DATE: July 9, 2011

SUBJECT: Improved transistor with higher current capability

PRODUCT AFFECTED: Ahlers P/N 810-30005-1 Annunciator (Enstrom ECD4078-1)

FIGURE 1.

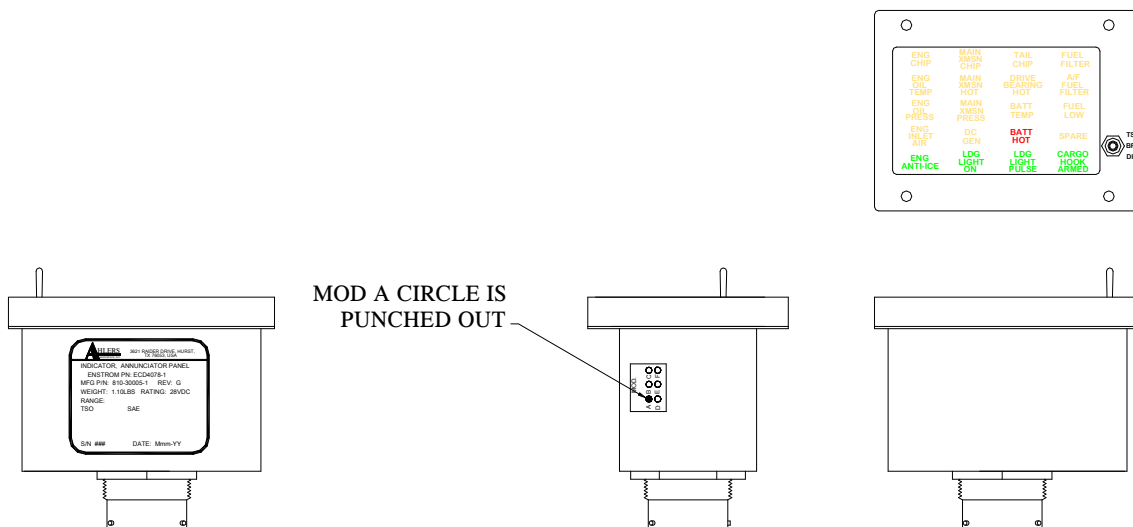
Verify 810-30005-1 annunciator panel has the modification by examining the modification sticker. The suggested location of the modification sticker is shown in figure 1. The MOD A circle will be punched out. If unit is identified as MOD A, it has been modified to this SB and is acceptable. No further work is required.

Punch out the circle adjacent the "A". Alternative to a punch, use a sharp knife to cut a triangle within the circle. Identify acceptable units with the Modification Label A.
